B.6 – TERRAIN FEATURES

On January 27, 2015, the Executive Committee requested that CMC provide supplementary information to the Casino Project (YESAB Project No. 2014-0002) to enable the Executive Committee to commence Screening. The Executive Committee considered comments from various First Nations, Decision Bodies and regulators on the adequacy of the Project Proposal in the preparation of the Adequacy Review Report (ARR). CMC provided a Supplementary Information Report (SIR-A) on March 16, 2015. Subsequently, the Executive Committee issued a second Adequacy Review Report (ARR No.2) on May 15, 2015 following a second round of review. CMC is providing this Supplementary Information Report (SIR-B) to comply with the Executive Committee's Adequacy Review Report ARR No.2; CMC anticipates that the information in the two SIRs and in the Proposal, when considered together, is adequate to commence Screening.

The Executive Committee has eight requests related to information presented in Section 6 Terrain Features and Section 20 Effects of the Environment on the Project: Terrain Instability of the Project Proposal and Section A.6 Terrain Features of the SIR-A. These requests and the corr

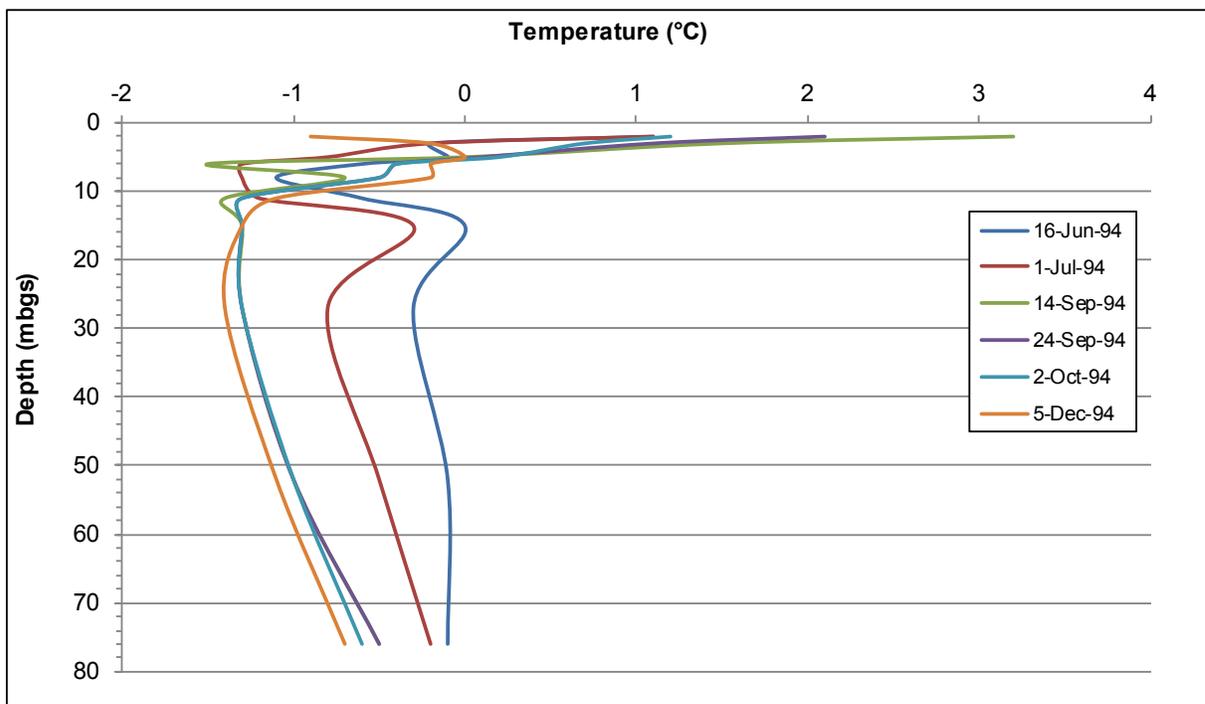
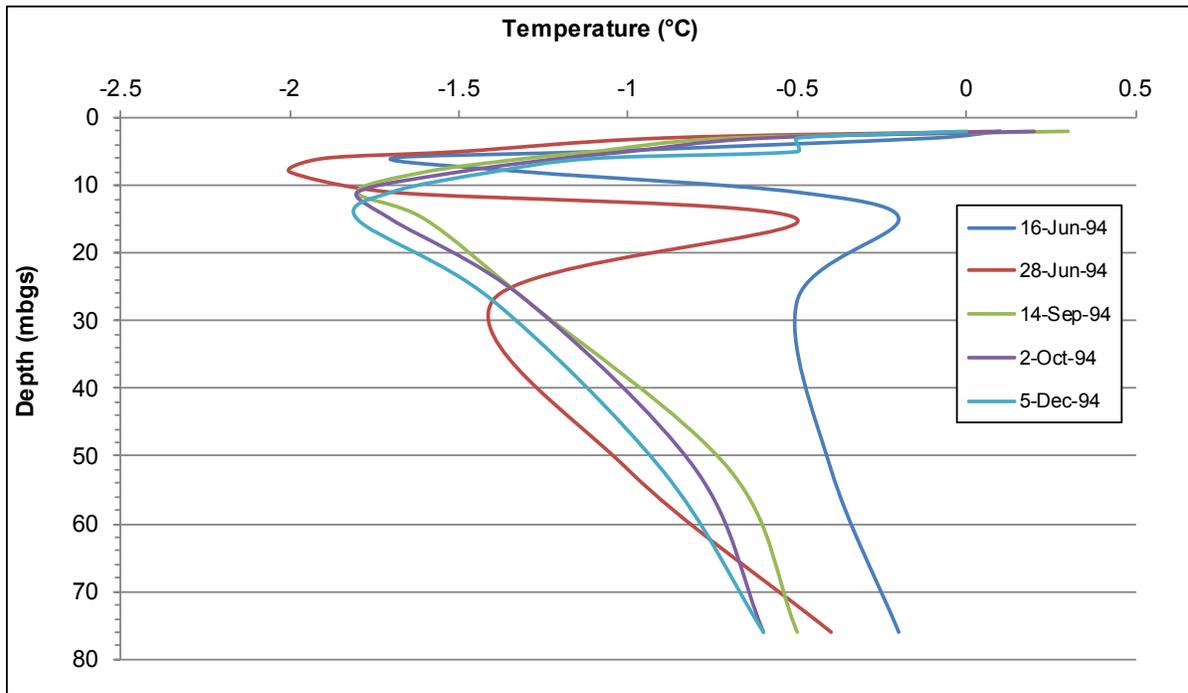
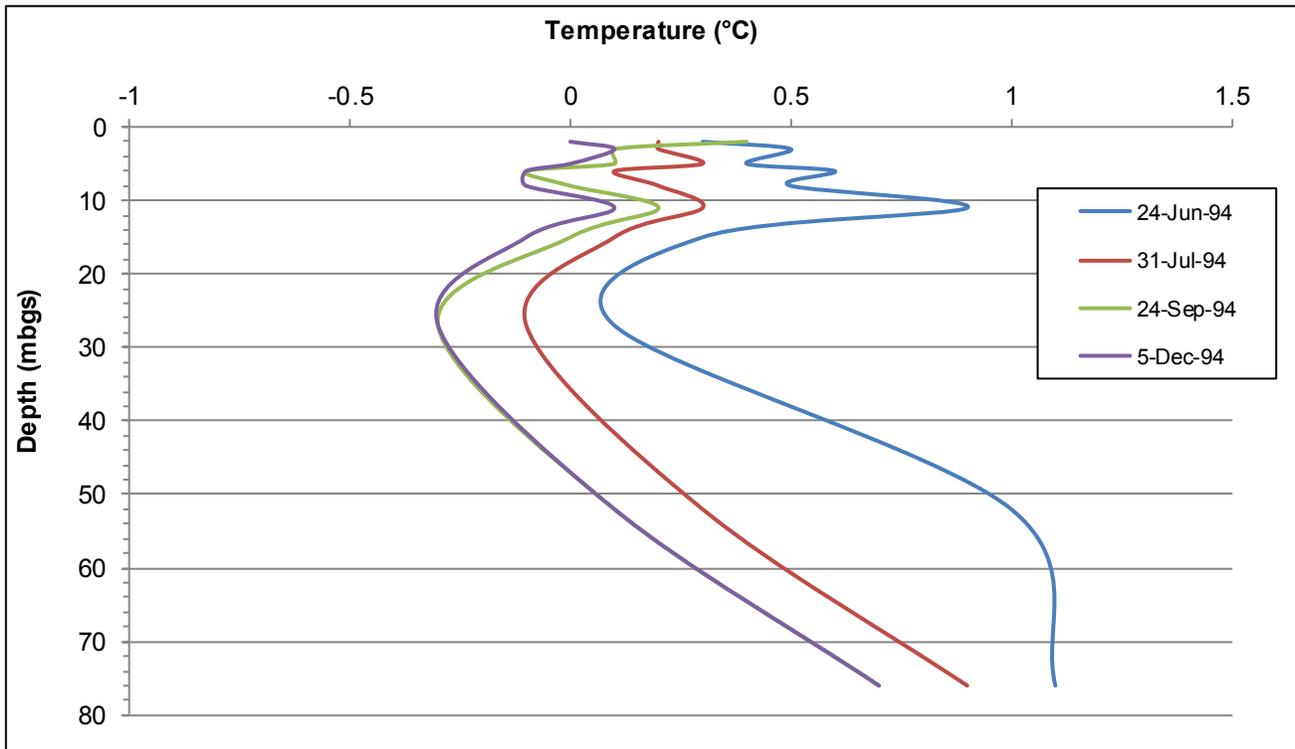
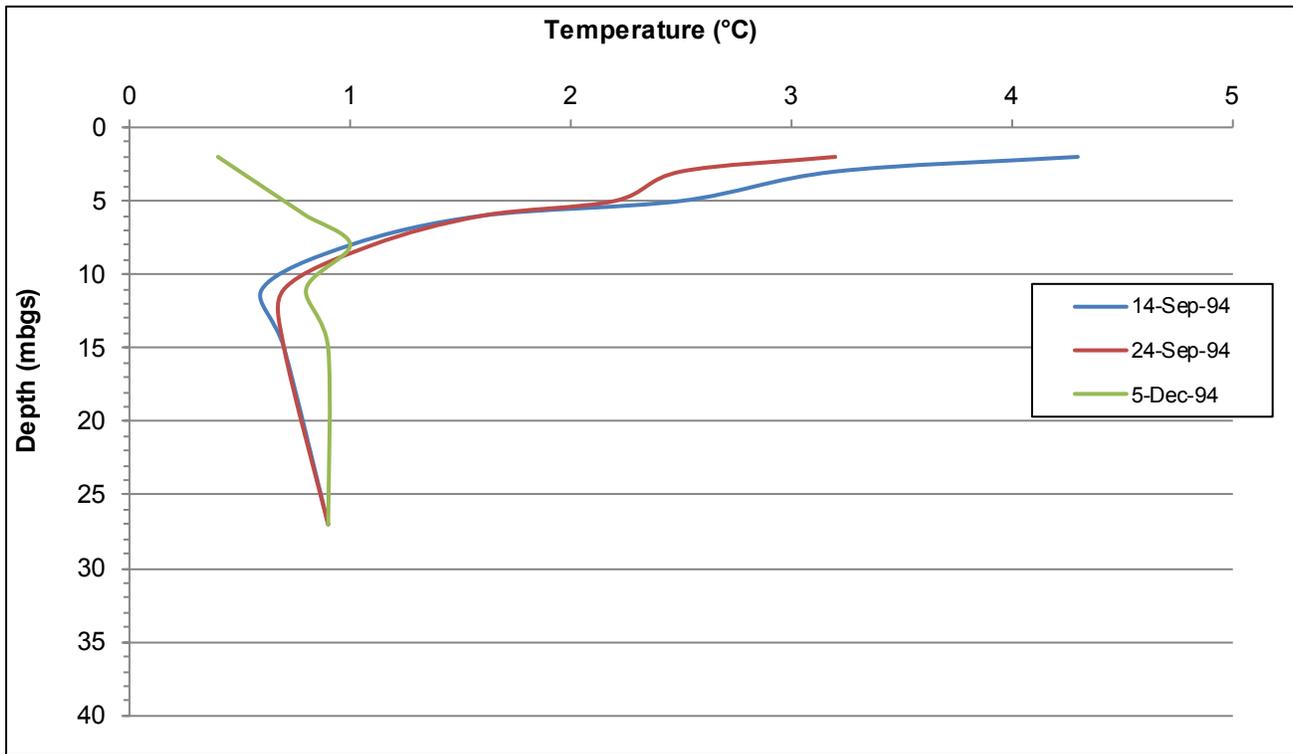
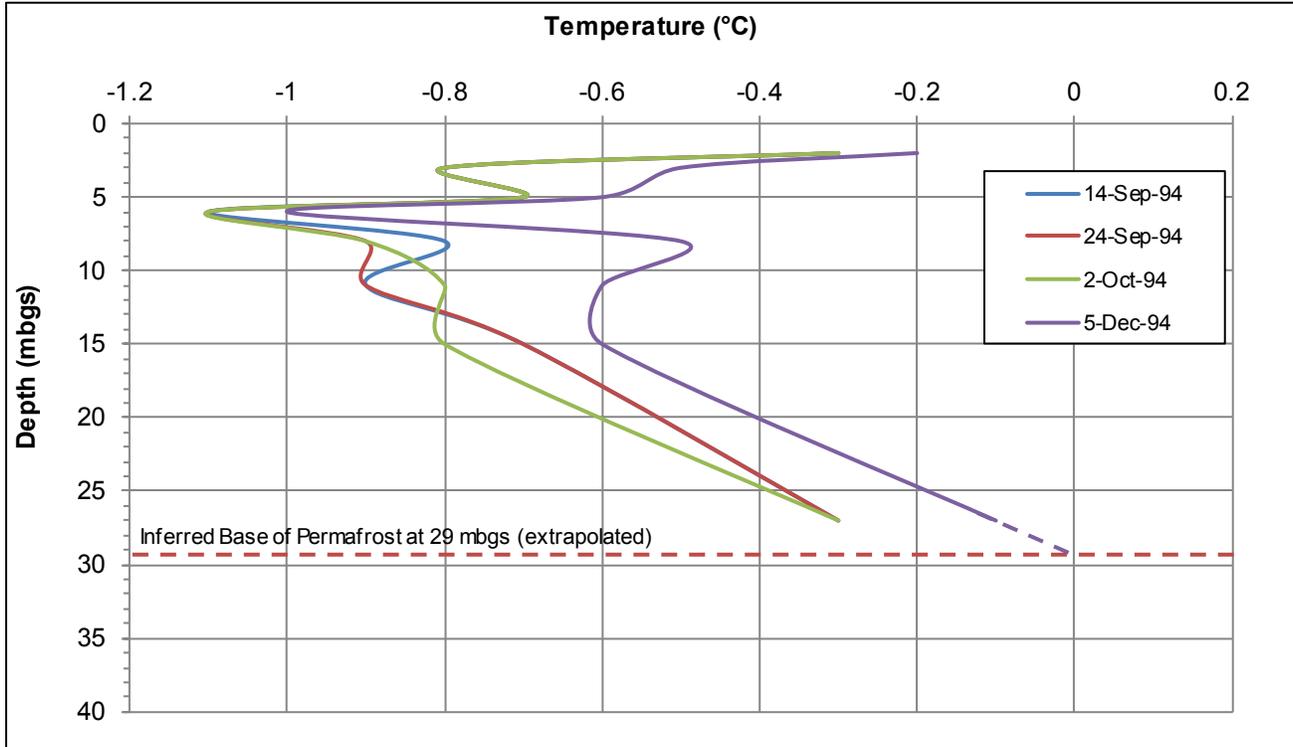
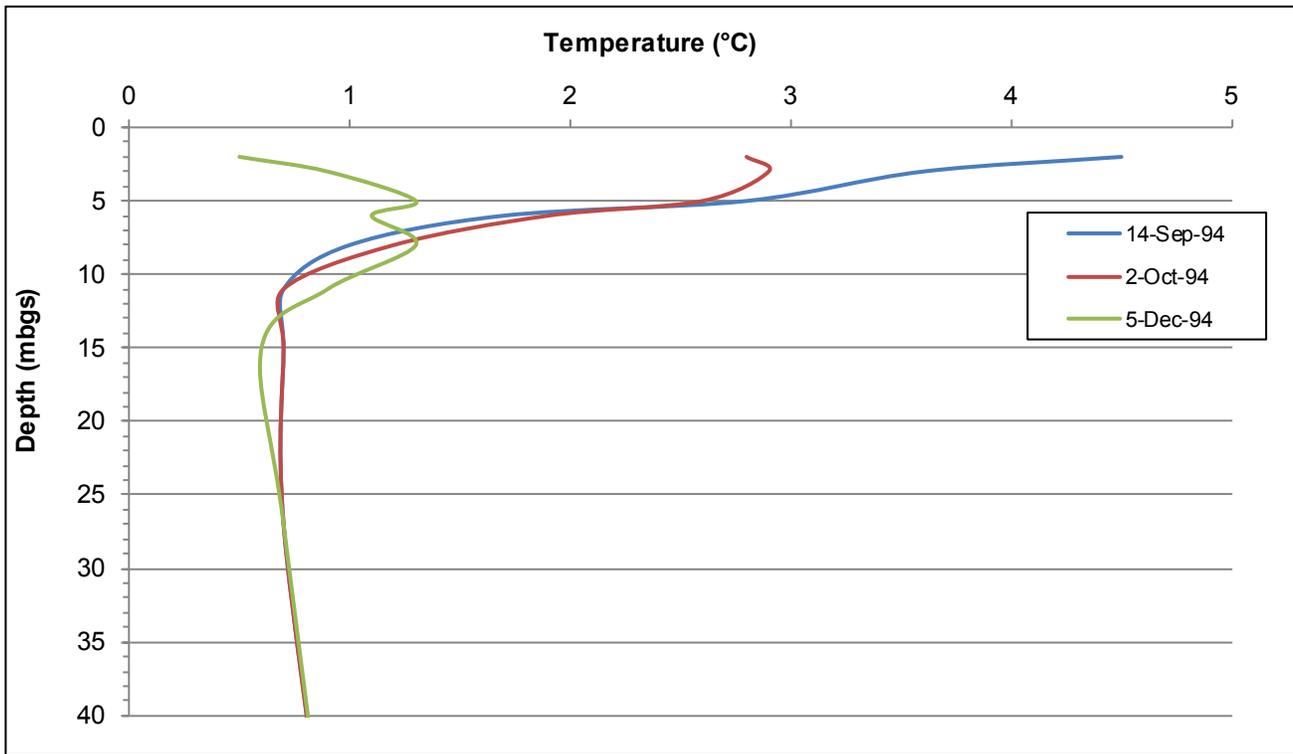
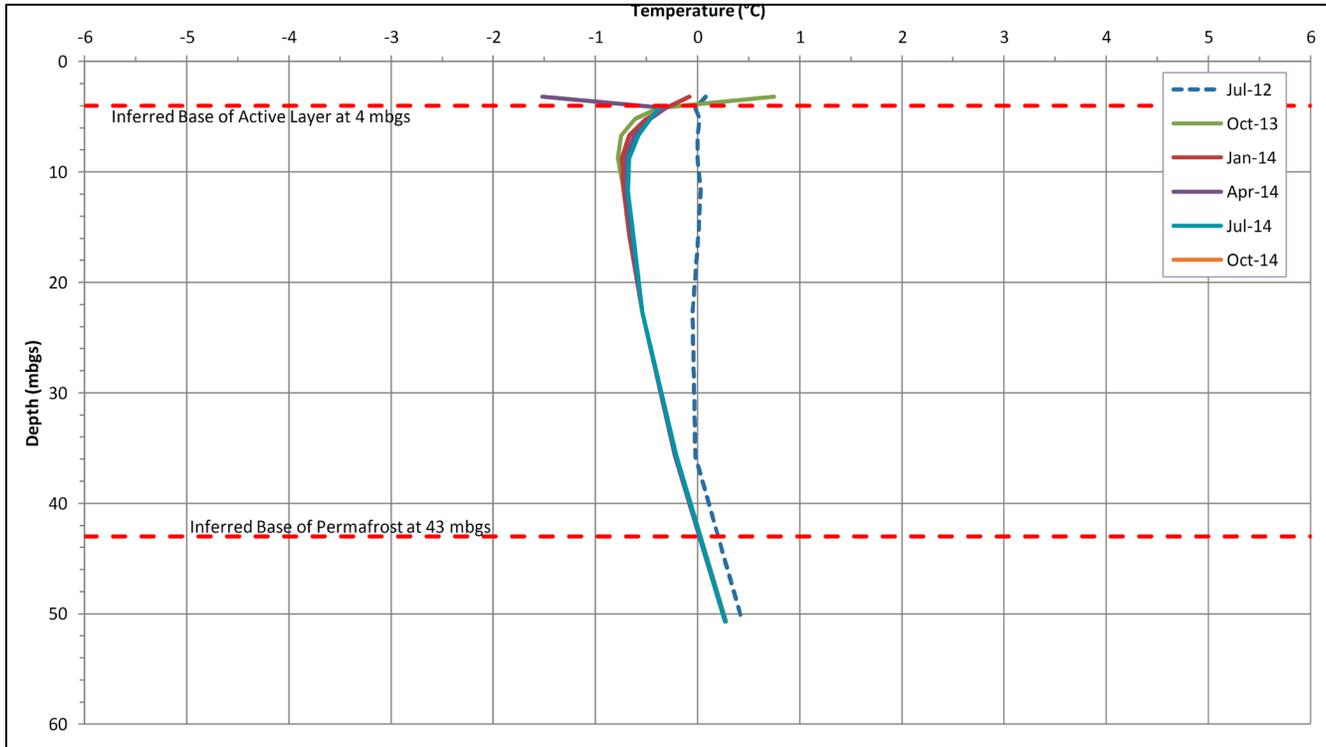
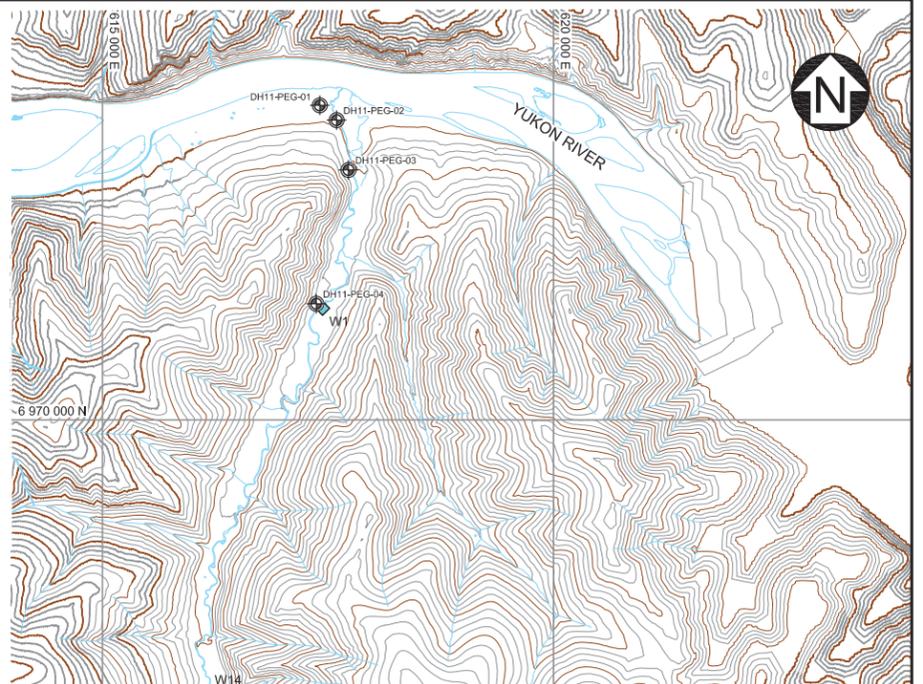
- a. A discussion regarding possible warming trend in the near surface based on the available ground temperature data. For example: Does the post 1994 ground temperature data exhibit any warming trend in the near surface temperatures? Is the active layer thickening?**
- b. If thermistors were installed in 2011 and 2012, up to four years of ground temperature data has been collected. Please report on this data.**
- c. If the 1994 thermistor cables are in the same location as the 2011 and 2012 thermistor cables. Please combine the data and provide some inferences as to long-term trends in mean annual ground temperatures.**
- d. The installation of thermistor strings to monitor ground temperatures and develop “trumpet curves” is an appropriate development by CMC. These data should be used to establish baseline mean annual ground temperatures values.**

The Executive Committee has requested that temperature data from 1994 thermistor sites be compared against adjacent locations with existing data sets, such as at 94-349 and DH12-03, to assess impacts of recent climate warming. While the two thermistor strings 94-349 and DH12-03 are the closest together of the 1994 and more recent thermistor installations, they are located approximately 260 m apart and on opposite sides of Casino Creek valley. The inferred base of permafrost at 94-349 was 29 mbgs based on the available 1994 data (Figure B.6.4-5). The inferred base of permafrost at DH12-03 is 43 mbgs based on data collected from 2012 to 2014 (Figure B.6.4-7). Since comparison of the two data sets shows the opposite trend as would be expected due to climate warming, impacts of recent climate warming are unable to be inferred by their comparison. Unfortunately, no other 1994 thermistor locations are proximal to locations where temperature data has been more recently recorded.

- a. Six thermistor strings were installed in drillholes in June through August 1994. Data at each of these locations was only manually downloaded once or twice per month until December 1994 or January 1995. All of the six 1994 thermistor strings have been reportedly damaged or lost and none are currently functioning (Appendix 7C). The available ground temperature readings for thermistor cables installed in 1994 are provided in Figure B.6.4-1 through Figure B.6.4-6, for each sampling month. Temperatures below zero were recorded in the deposit area at 94-321, 94-331, and 94-334, and downstream of the proposed TMF Embankment at 94-349. Recorded temperatures were above zero at sensors 94-344 and 94-355 located in Casino Creek Valley.
